DESIGN MEMORANDUM NO. 14.1

RECREATION FACILITIES and PUBLIC USE AREAS

Little Goose Reservoir

SUBJECT: Little Goose Project, Design Memorandum No. 14.1, Recreation
Facilities and Public Use Areas, Little Goose Reservoir

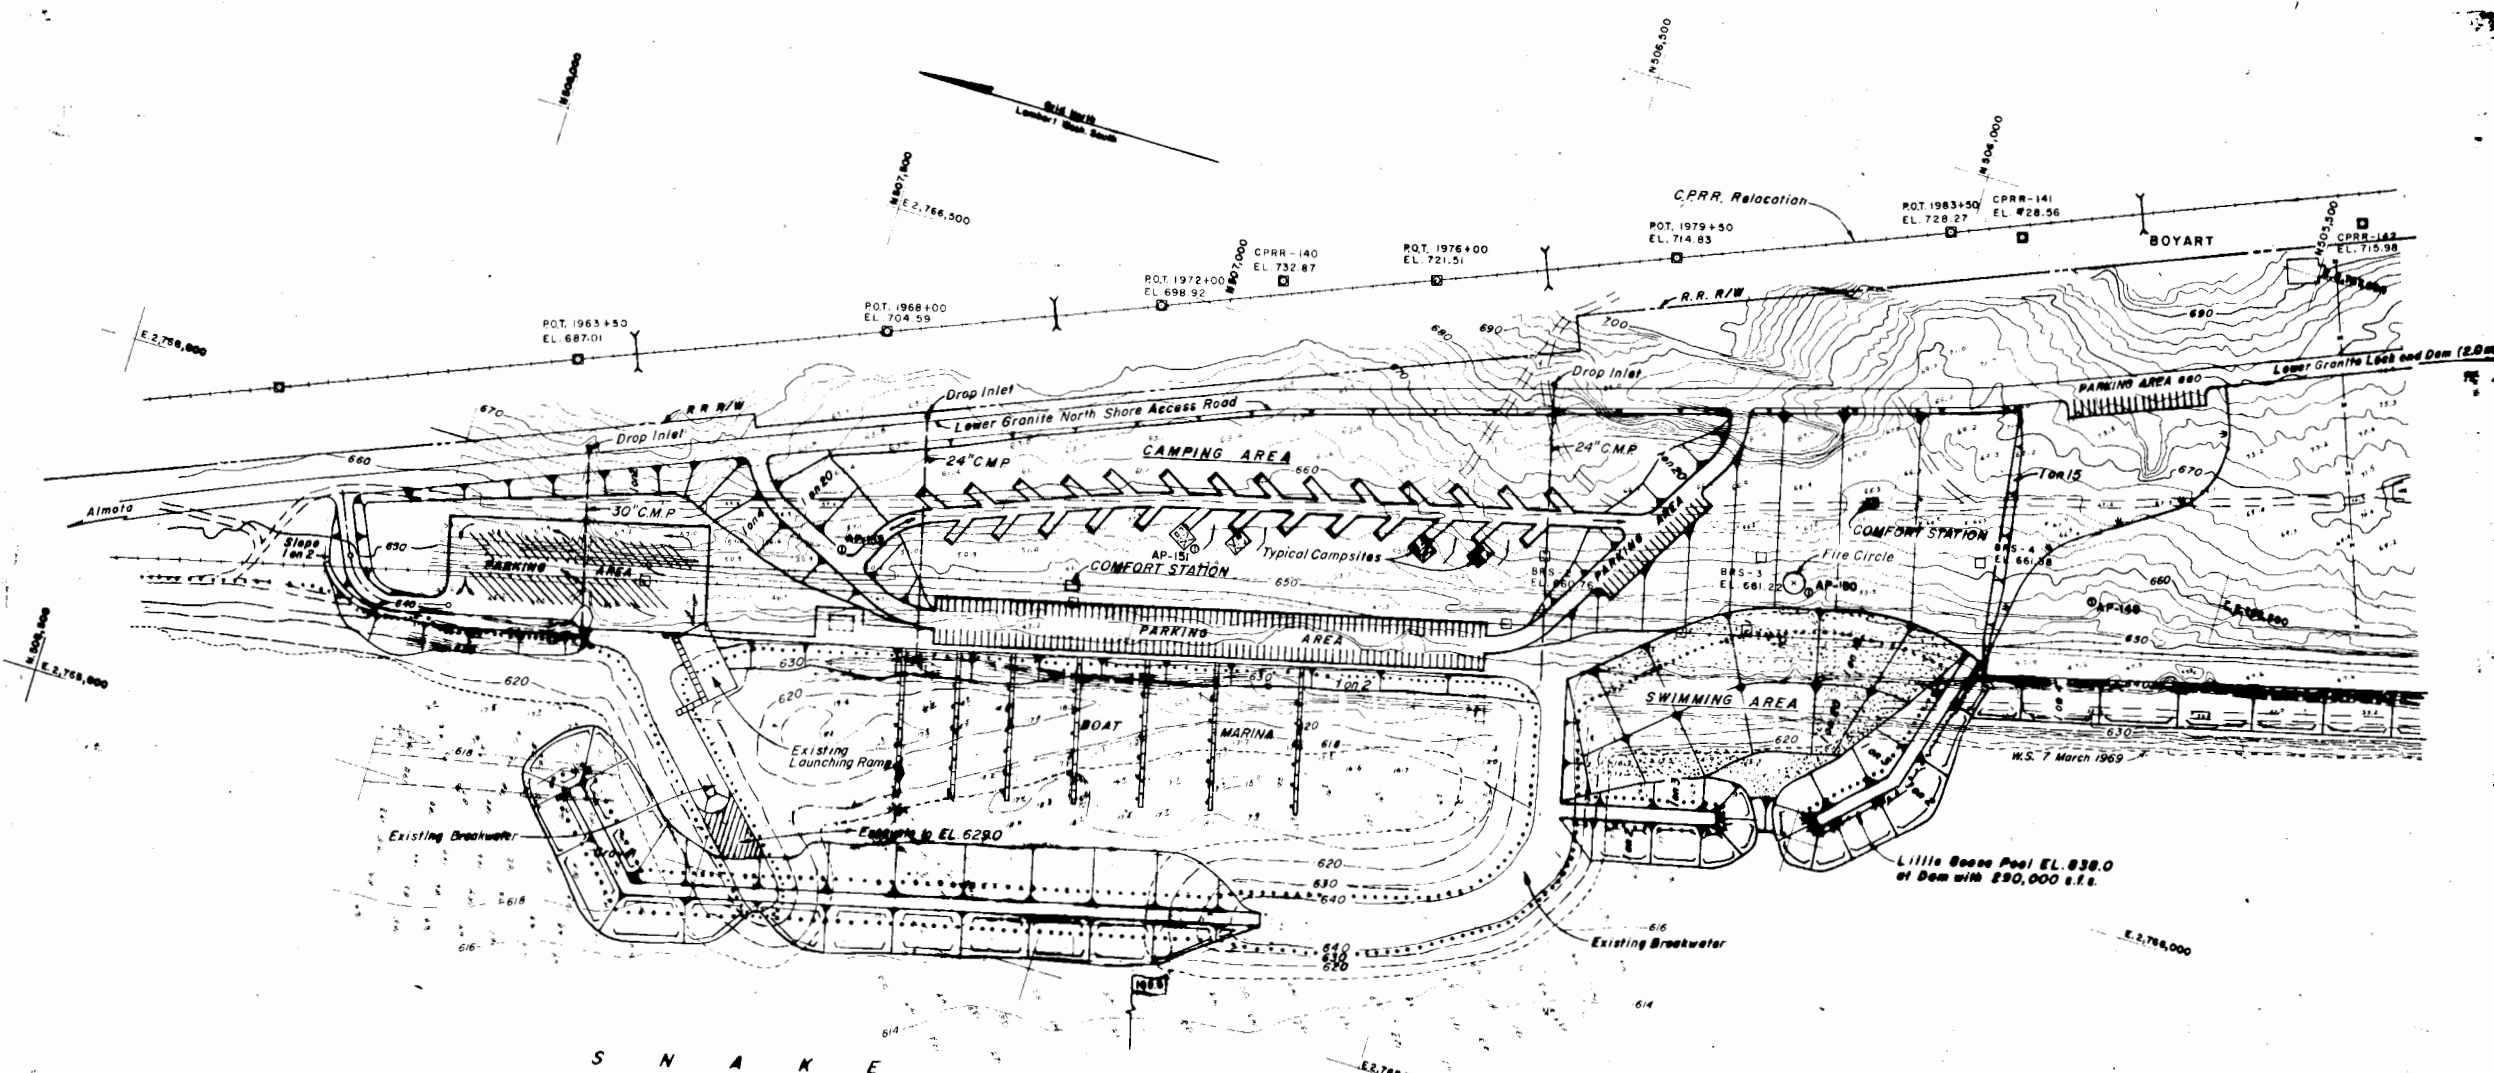
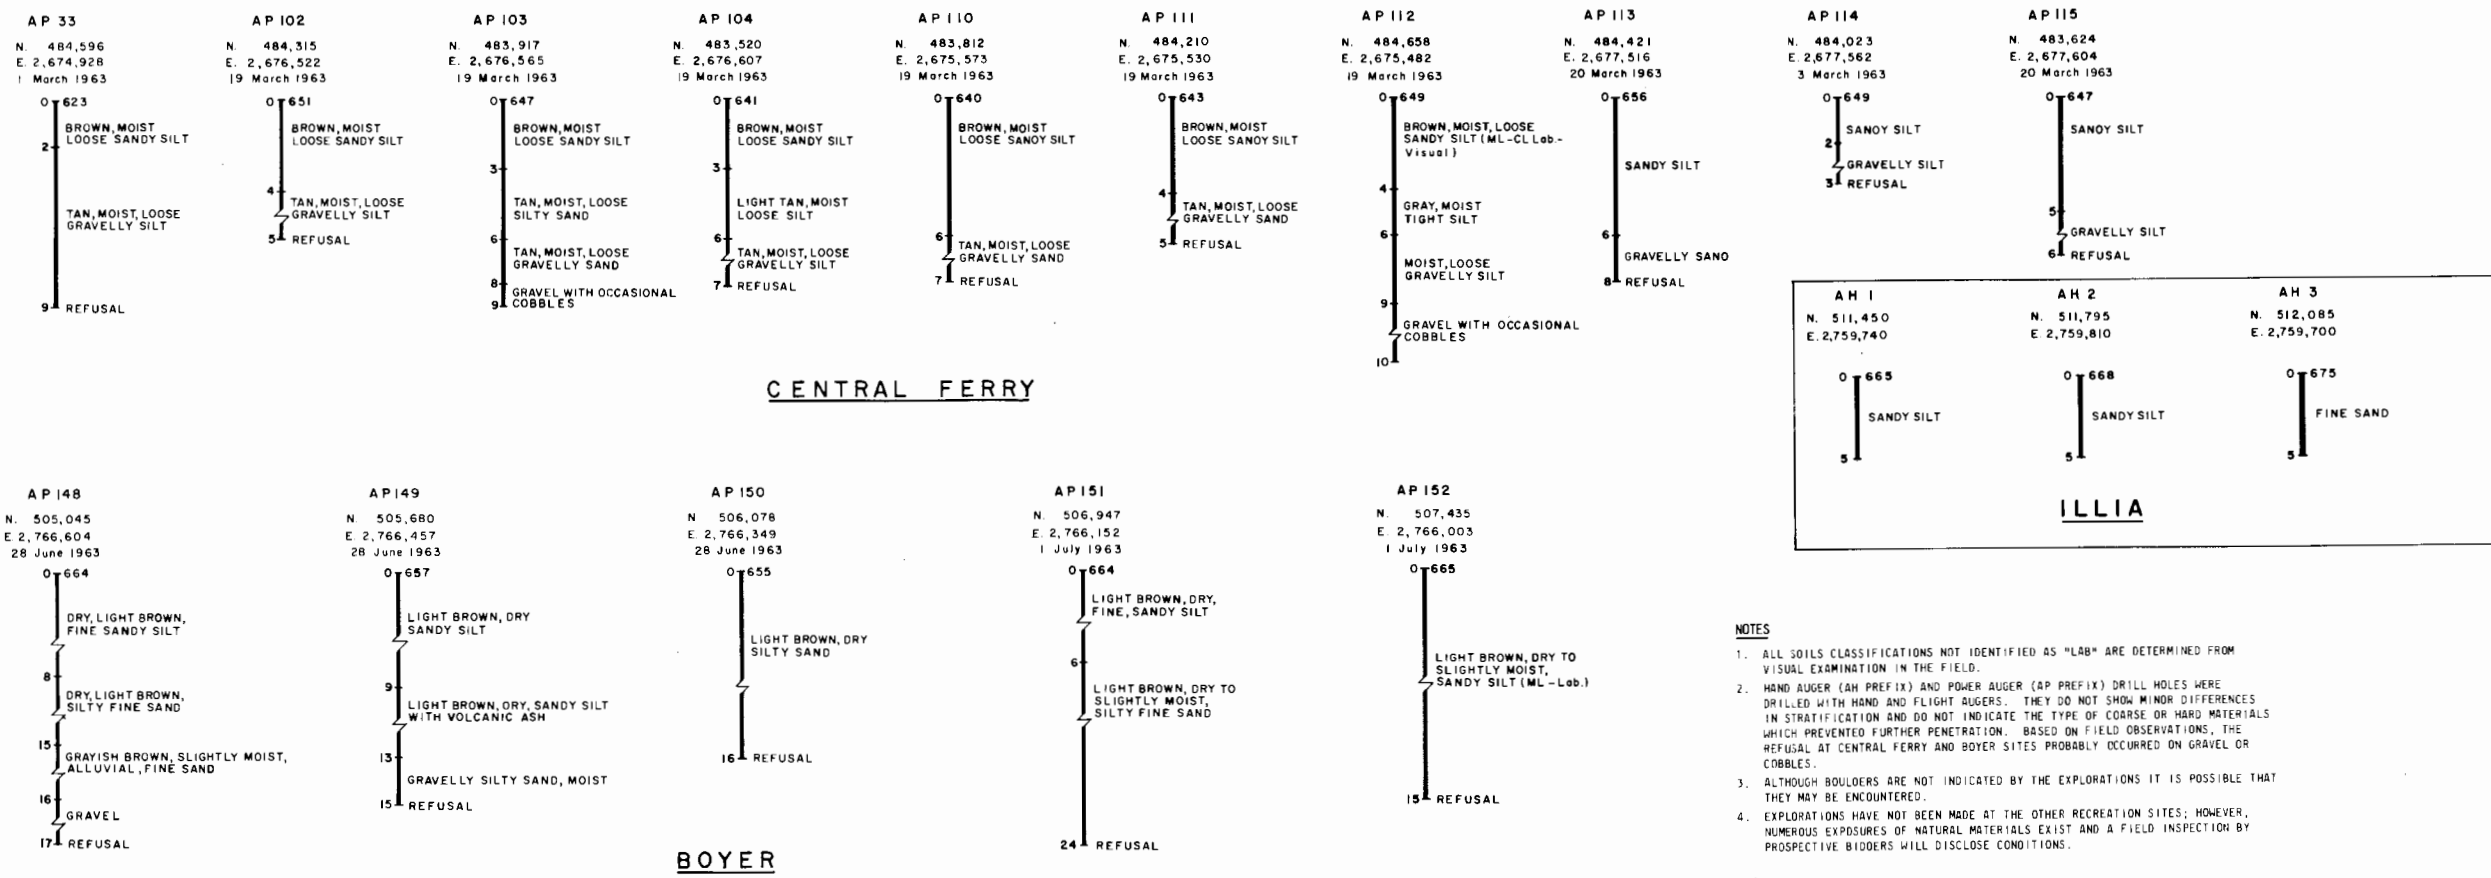
g. Plate 9 - Boyer Site. The boat harbor entrance channel plan should be evaluated relative to currents from Lower Granite project discharges.

4. Plate 9, Boat Marina at Boyer. Consideration should be given to extending the end of the proposed main breakwater another 25 to 50 feet to reduce wave action within the marina. The diffraction analysis for Boyer, on revised Plate 4, indicates that waves larger than 1.0 feet will enter the harbor area. When reflected from the harbor side of the main breakwater, an unsatisfactory wave climate will probably result in the moorage area.

(5) At Boyer, a small change was made in the breakwater design after wind wave studies were completed. At this site the port of Whitman County also performed considerable grading work by constructing about one-half of the breakwater, grading the boat basin, and constructing the launching ramp. The estimated cost for the Corps to construct this work under reservoir conditions is \$158,000. To balance this work, the Corps will construct a portion of the tieup dock for this site at an estimated cost of \$132,000. Revised cost estimate is shown in Table 8. As reflected in the revised cost estimate, the cost of each section and reasons for variance in cost are:
